Proposed secondary dwelling to residence at
42 Pringle Ave Belrose
for John and Therese Hajtkian

date:	scale	dwg. no.
July 2018	1: 200	355.1A

THIS PLAN TO BE READ IN CONJUNCTION WITH
MOD2019/0091
NORTHERN BEACHES COUNCIL

Newbuild Design and Drafting Robert Geoghegan 17 Jocelyn Street North Curl Curl 2099 m. 0419907222 e. robge@bigpond.com		
PROPOSED SECONDARY DWELLING TO SINGLE RESIDENCE 42 PRINGLE AVE BEUROSE FOR JOHN & THERESE HAJAKIAN		
date	scale	dwg.no.
July 2018	1:100	355-3A

LANDSCAPING & STORM WATER PLAN: 1:200

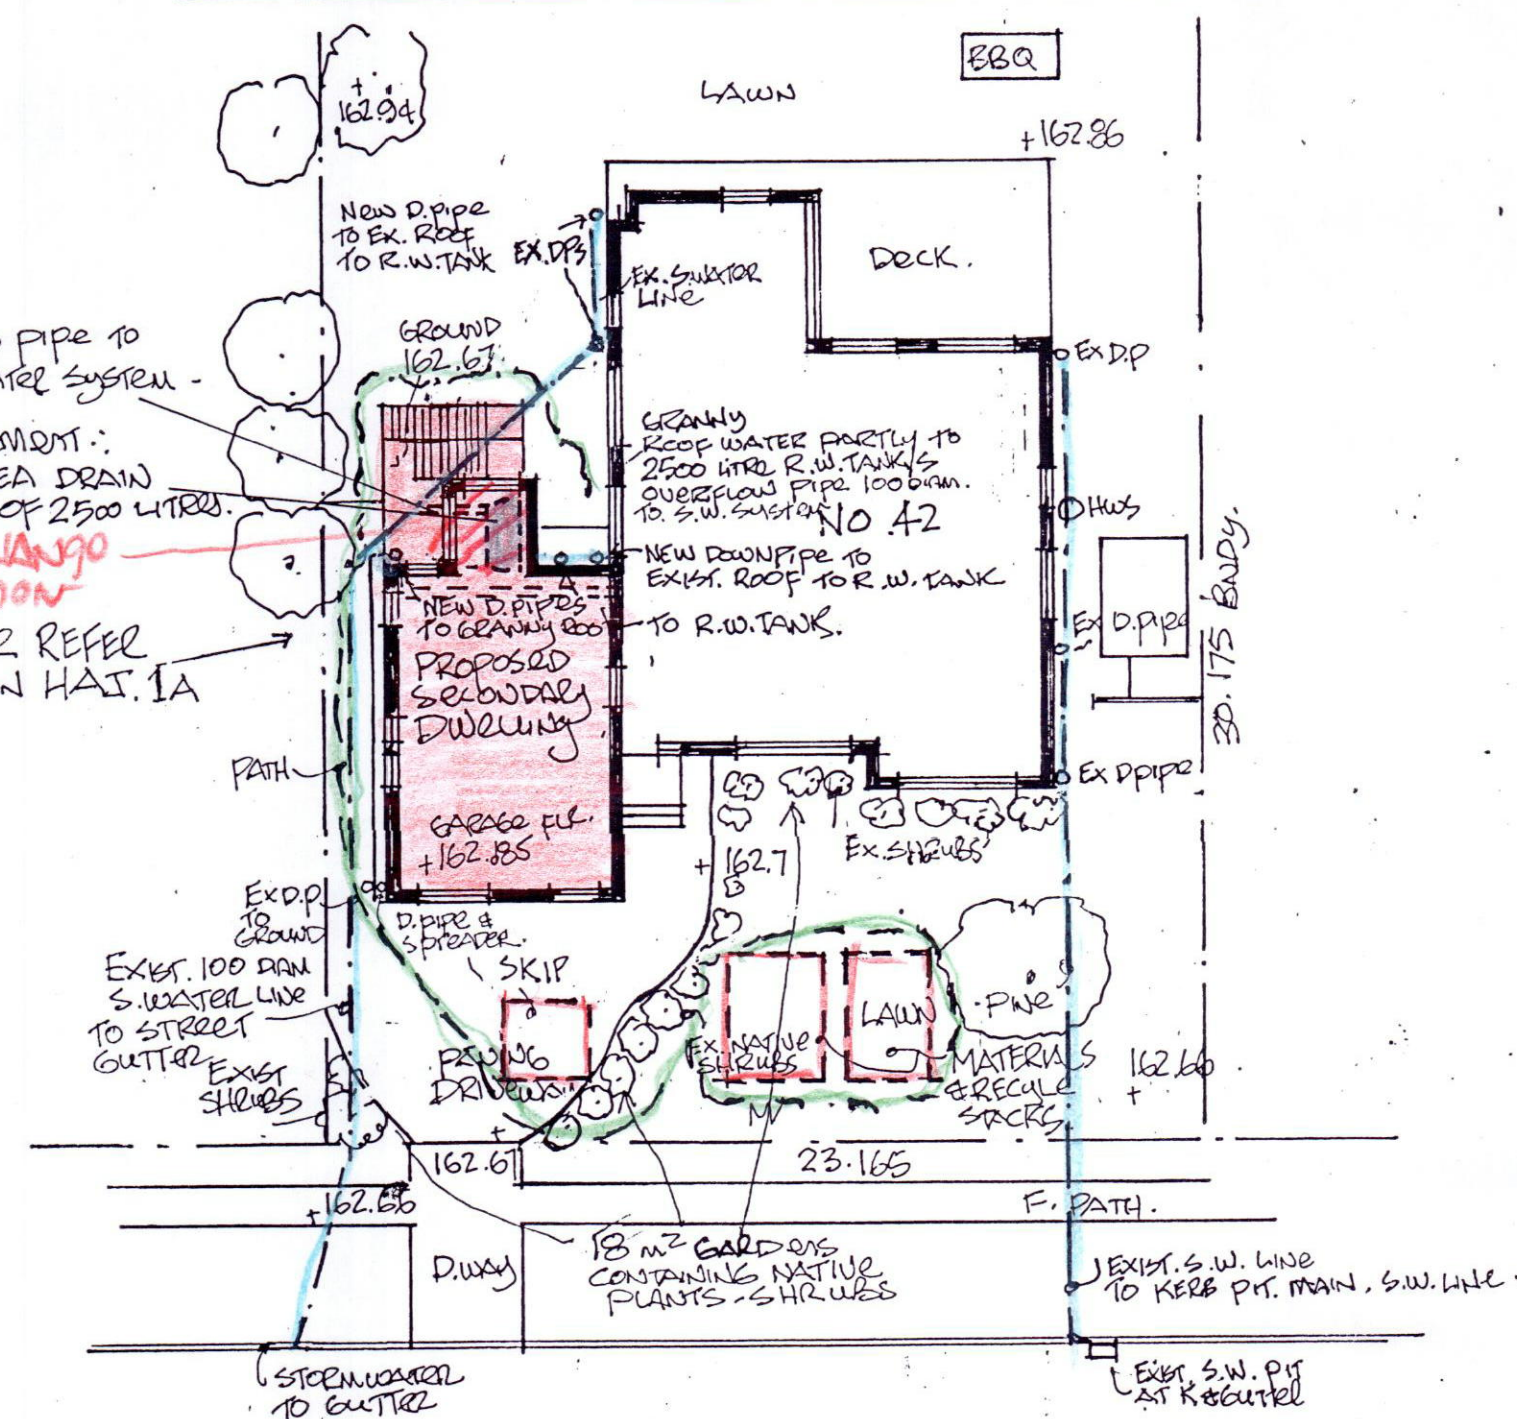
SECT. 96. CHANGE —
MEALS ROOM
STORM WATER REFER
DETAIL PLAN HAT. 1A

15.2.19	A.	* SITE ANALYSIS PLAN GRANNY MEALS ROOM MOVED NORTH 1050 AWAY FROM HOUSE * STOREN WATER PLAN REVISED AS HAST.1
DATE	NO	AMENDMENT.

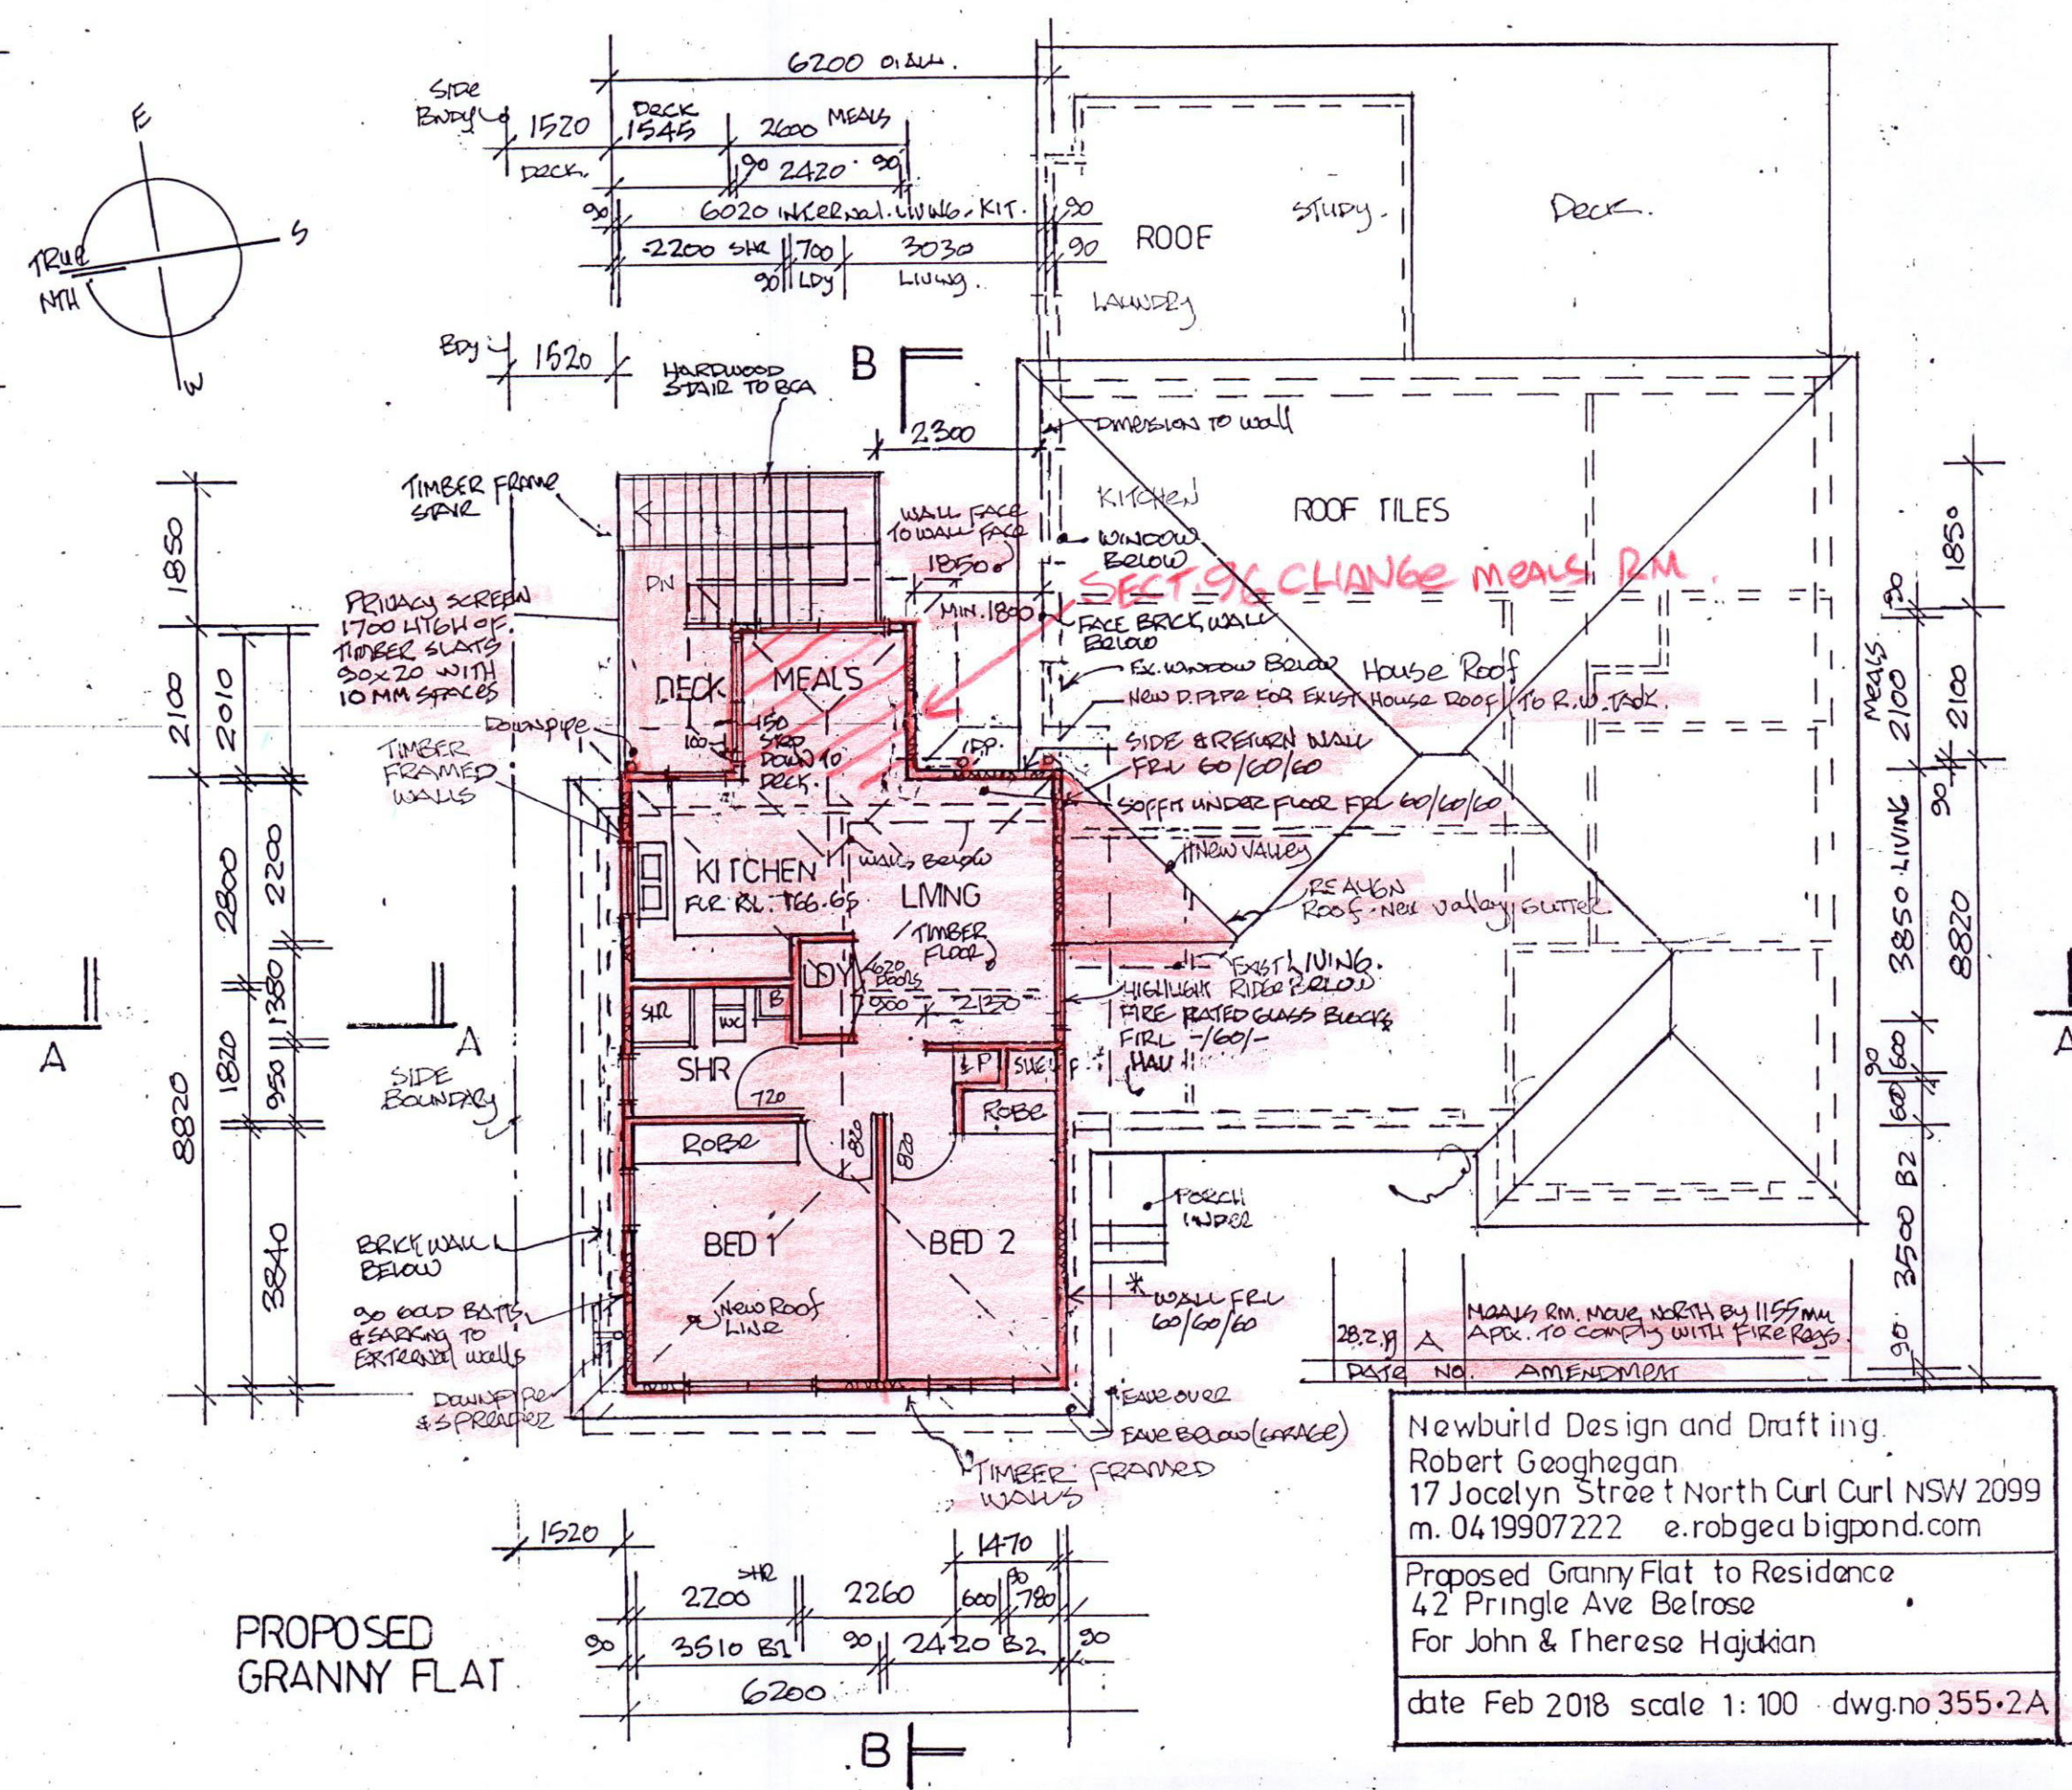
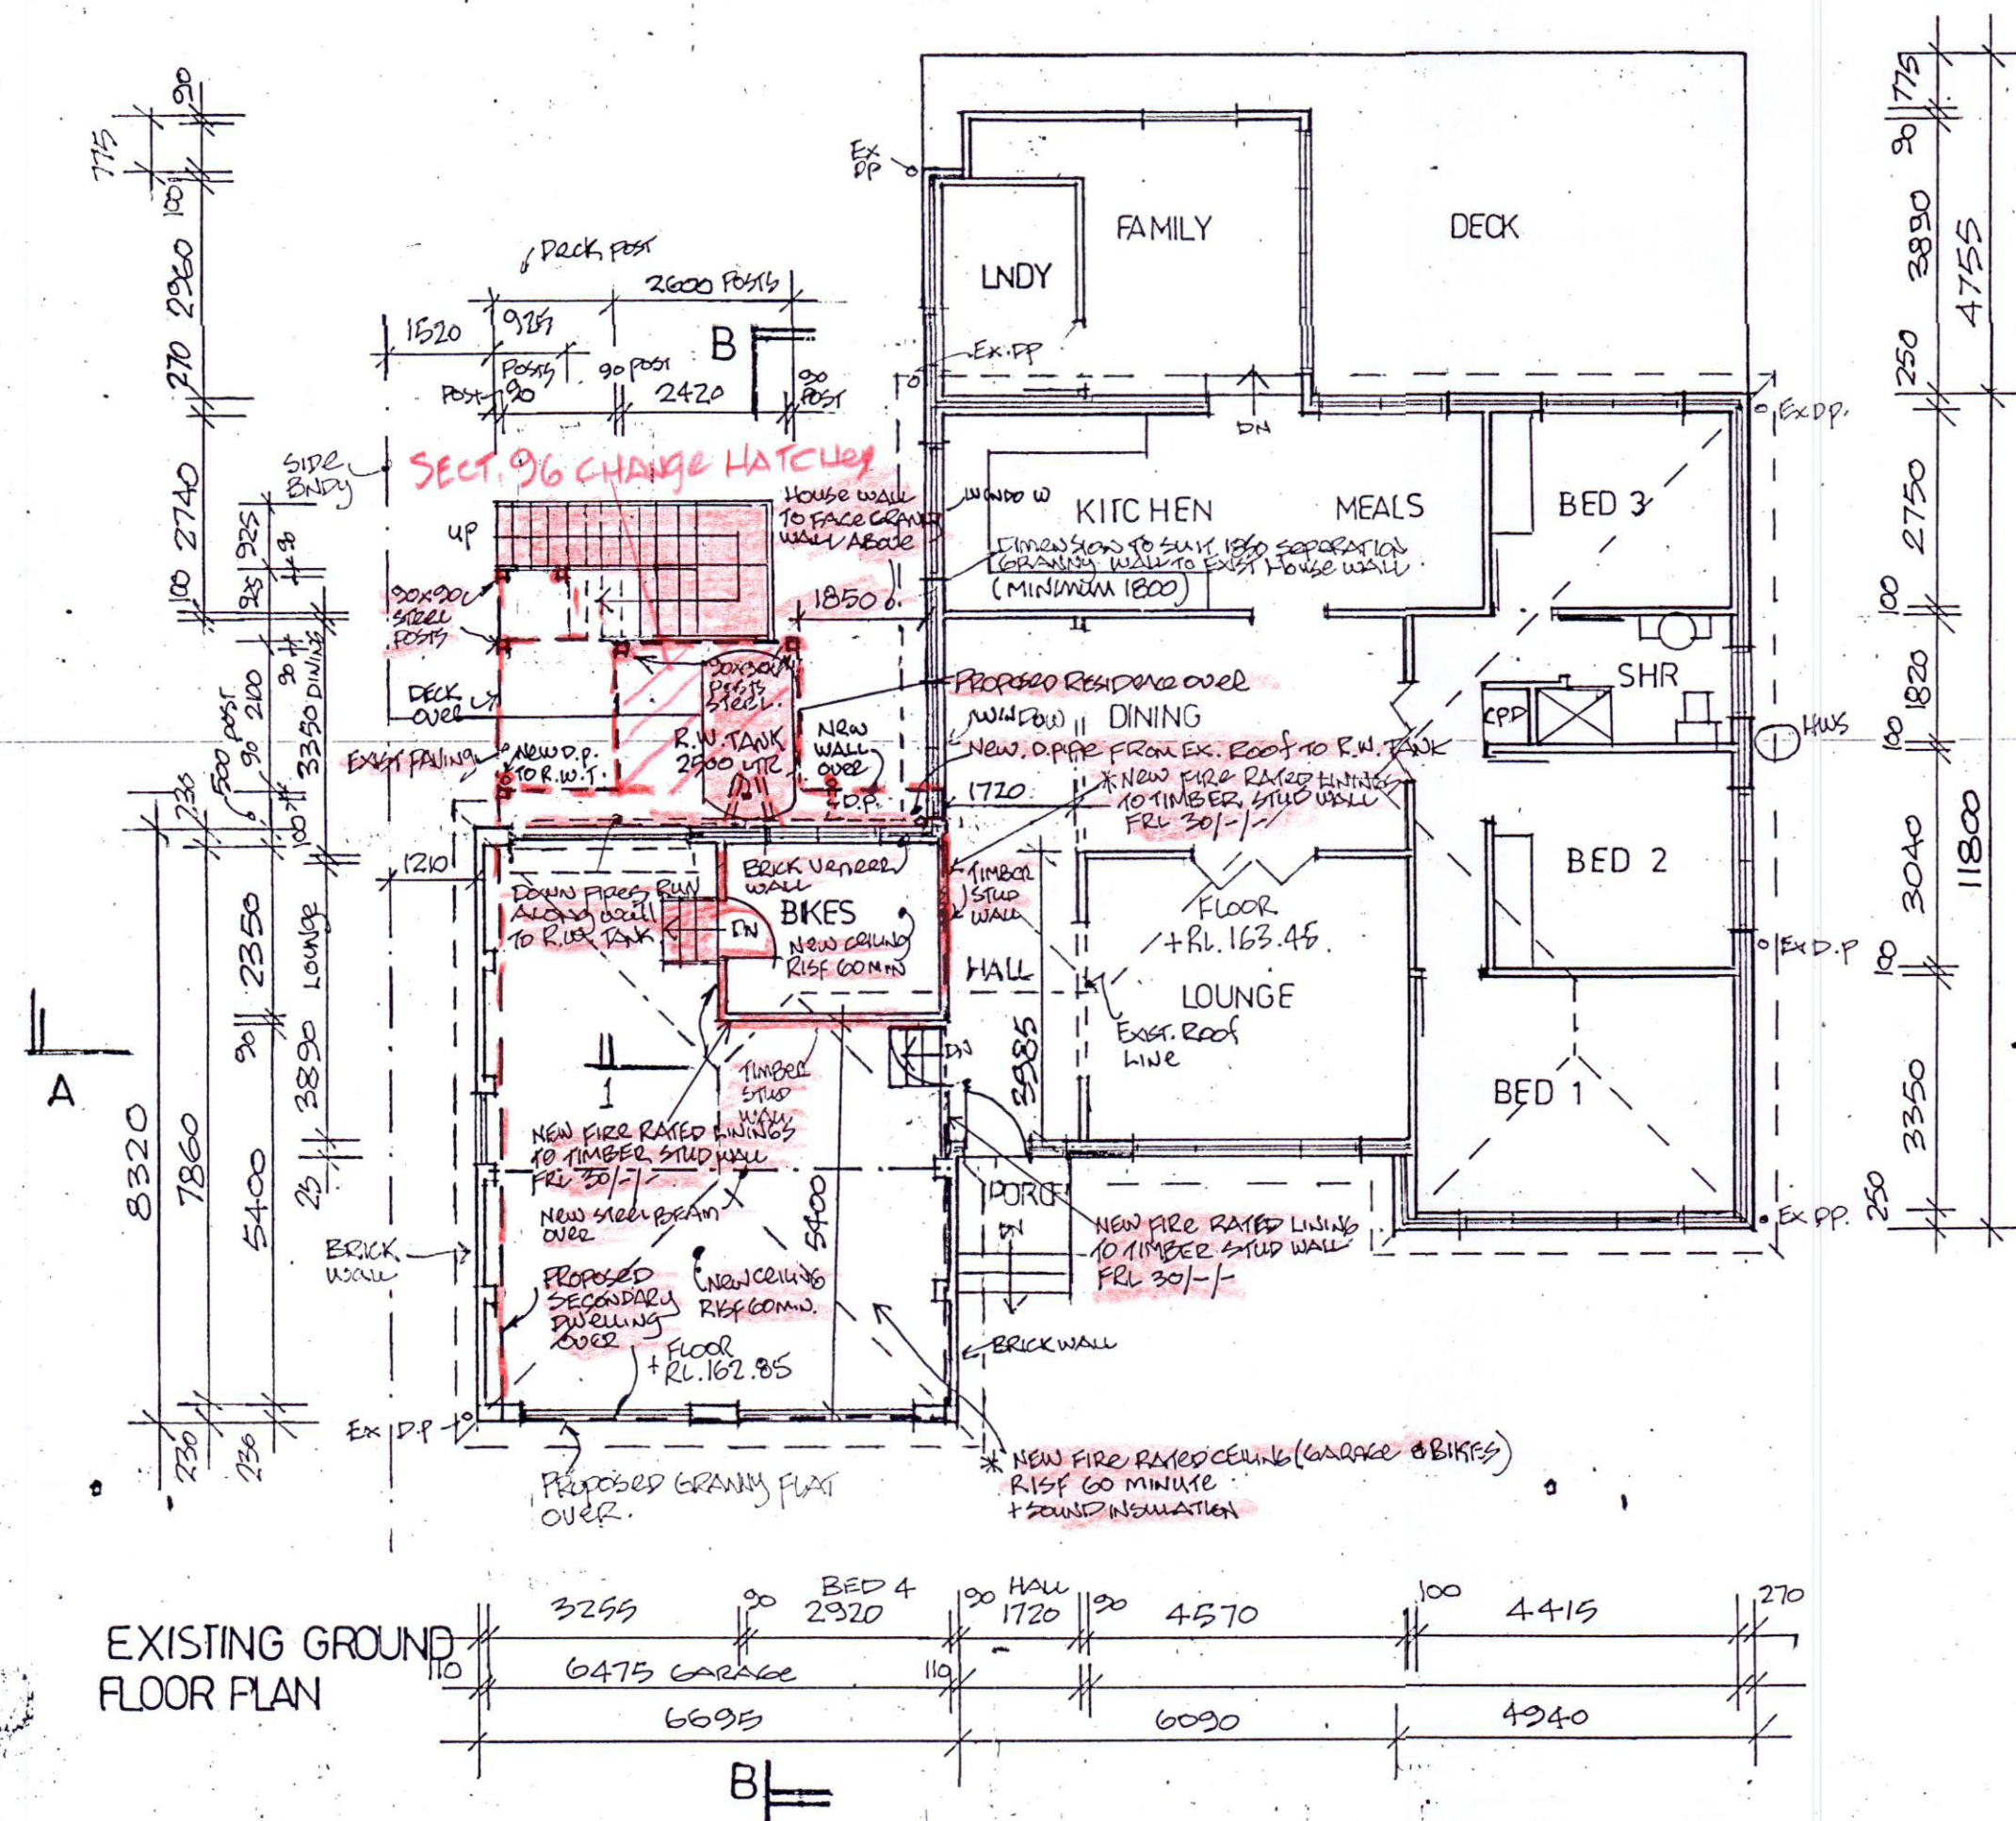
28.2.19	A	Due to fire separation 1200 Road, Bug-Bug, MEALS ROOM MOVED NORTH BY APPROX. 1155mm TO COMPLY WITH FIRE RGS.
DATE	NO	AMENDMENT
